V2500 Propulsion System — Nacelle

**NACELLE — PNEUMATIC — FLANGE, FAN AIR VALVE SUPPORT  
— REPLACEMENT OF**

**V2500-NAC-36-0005**

LH Pylon Valve Support Flange Replacement  
Figure 1 (sheet 1)

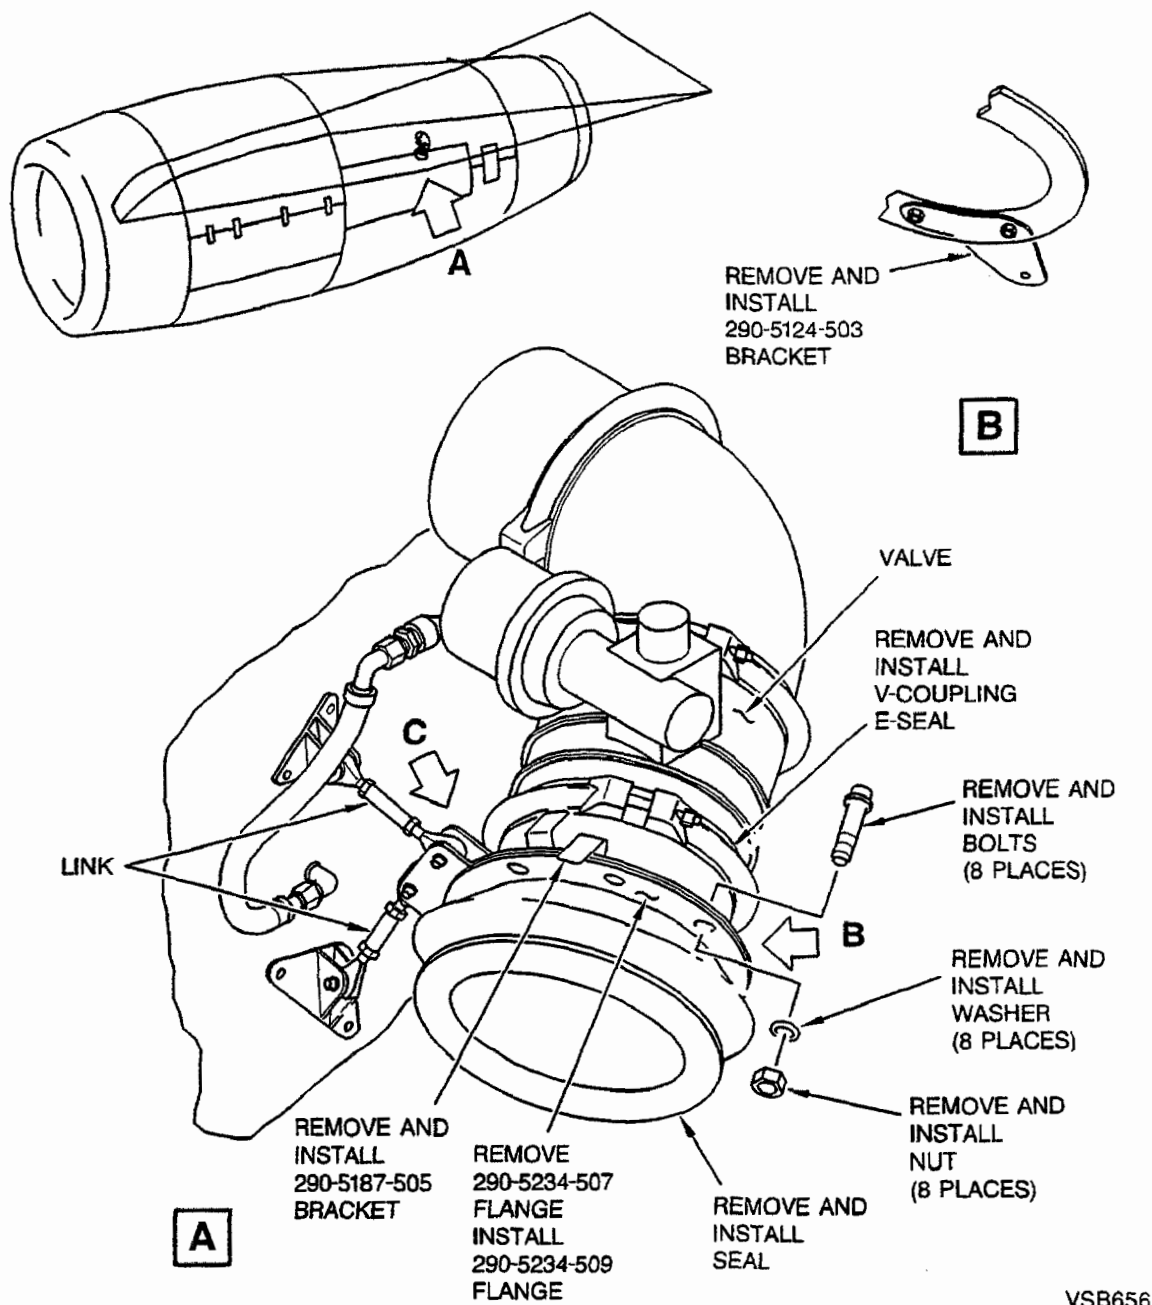
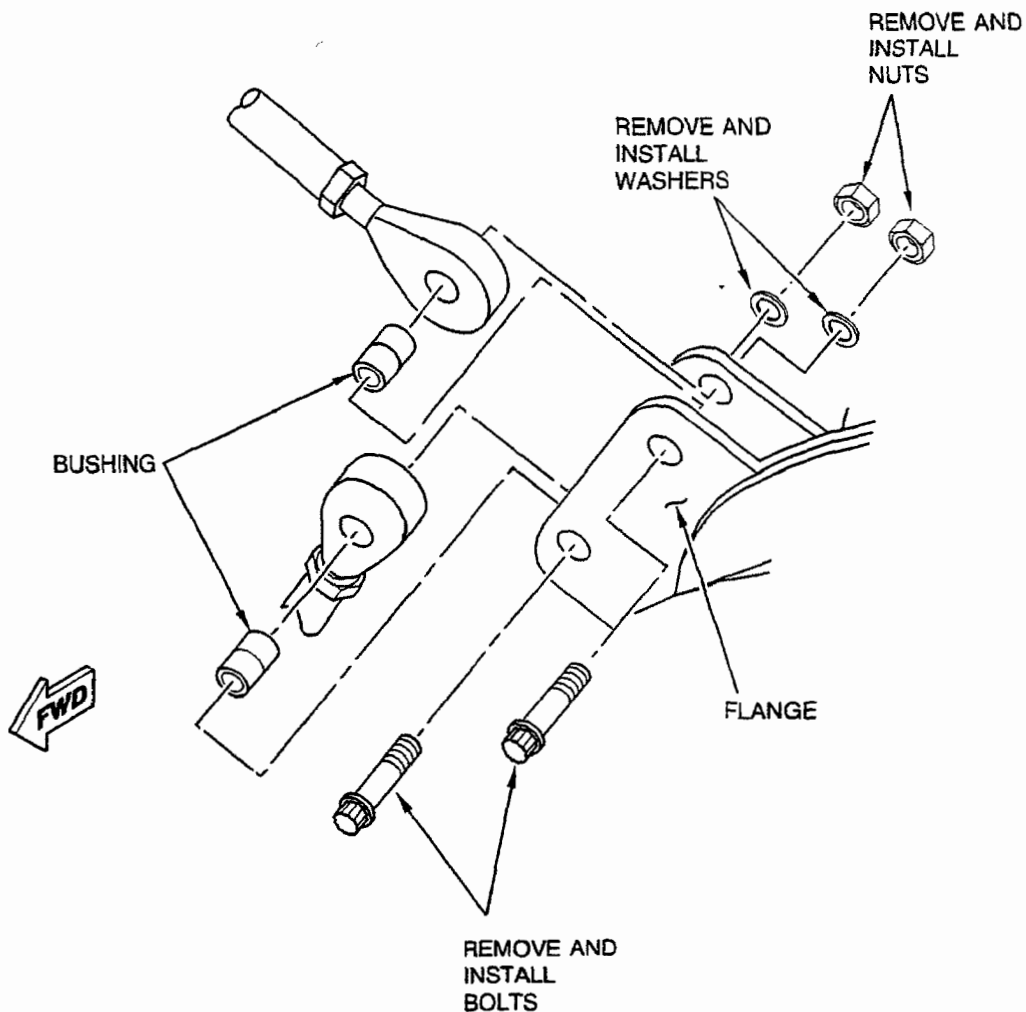
- (1) Remove the nuts, washers, bushings, and bolts and disconnect the links from the 290-5234-505 (-506) flange. Refer to Figure 1 (Figure 2).
- (2) Loosen the clamp and remove the 290-5234-505 (-506) flange and e-seal from the valve.

- (3) Remove the nuts, washers, bolts, seal, 290-5187-505 (-507) bracket, and 290-5124-503 (-504) bracket from the flange. Discard the flange.
- (4) Install the 290-5124-503 (-504) bracket, 290-5187-505 (-507) bracket, and seal on the 290-5234-509 (-510) flange with the bolts, washers, and nuts.

- (5) Put the e-seal and 290-5234-509 (-510) flange in to position on the valve and loosely tighten the clamp.
- (6) Connect the links to the 290-5234-509 (-510) flange with the bushings, bolts, washers, and nuts.

- (7) Make sure the seal on the flange is aligned with the mating duct on the thrust reverser and there is no pre-load on the duct.
- (8) Tap around the outside of the clamp with a soft face hammer.

- (9) Tighten the clamp to the torque value stamped on the clamp.
- (10) Tap around the outside of the clamp with a soft face hammer.
- (11) Tighten the clamp to the torque value stamped on the clamp.
- (12) Tap around the outside of the clamp with a soft face hammer.
- (13) Tighten the clamp to the torque value stamped on the clamp.
- (14) Torque the four link attach nuts to 50-70 in-lb (5.7-7.9 Nm).
